## PLAN COMMISSION

November 14, 2023

- c. PLAN REVIEW – Review site, building, and related plans submitted by Richard Barrett, BLVD, for a multitenant residential building (Emerald Row IV) on the property at 7951 S. 6<sup>th</sup> St. and surface parking on the property at 7971 S. 6<sup>th</sup> St. (Tax Key Nos. 813-9063-000 and 813-9062-000; *2<sup>nd</sup> Aldermanic District*).  
More info at ZoningHub: <https://s.zoninghub.com/6L44RAGQS9>

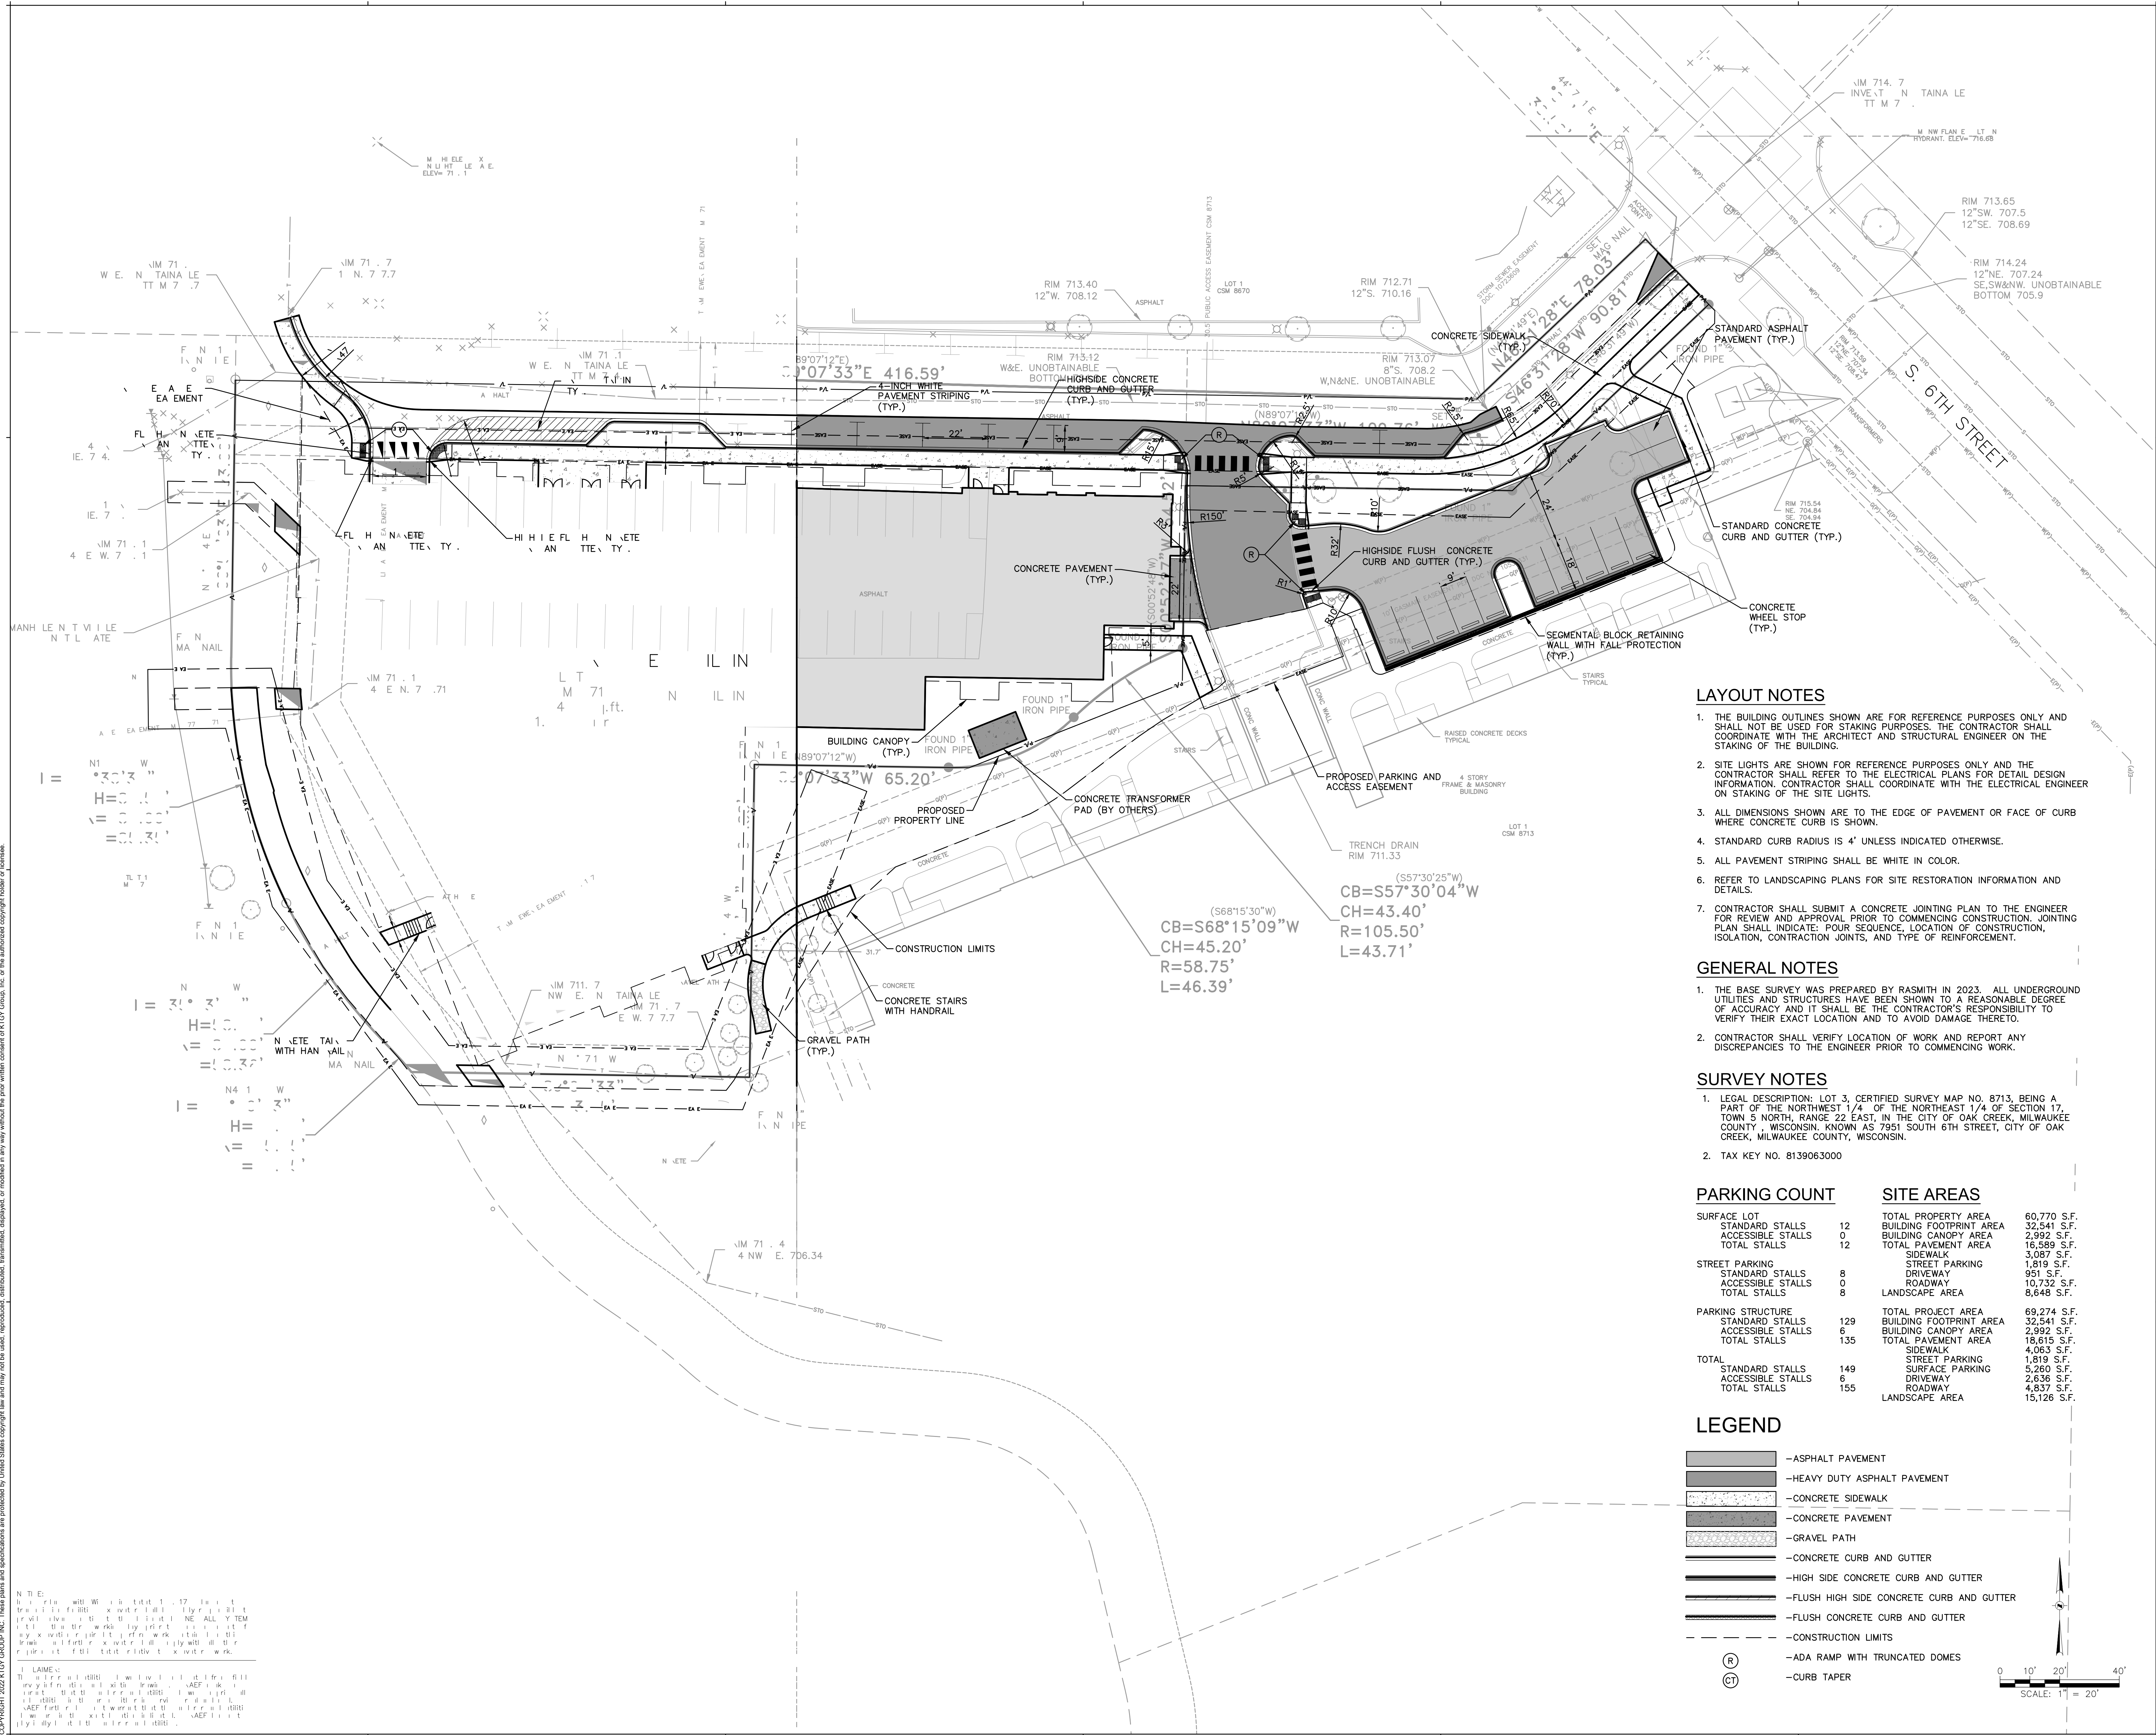
- a. Will submit the required signage documents through the Sign Appeal process when it has been designed
- 7) Can you please provide an example of where the proposed perforated metal panels were installed? We would like to see how this treatment interacts with the public space. We would also like to suggest that the wall incorporate a mural or other artistic element, which could utilize a treated metal component, that plays off the natural area.

- a. Refer to elevation sheets A3-100, A3-101, A3-102, A3-103, A3-104 for location of two types of metal panels.
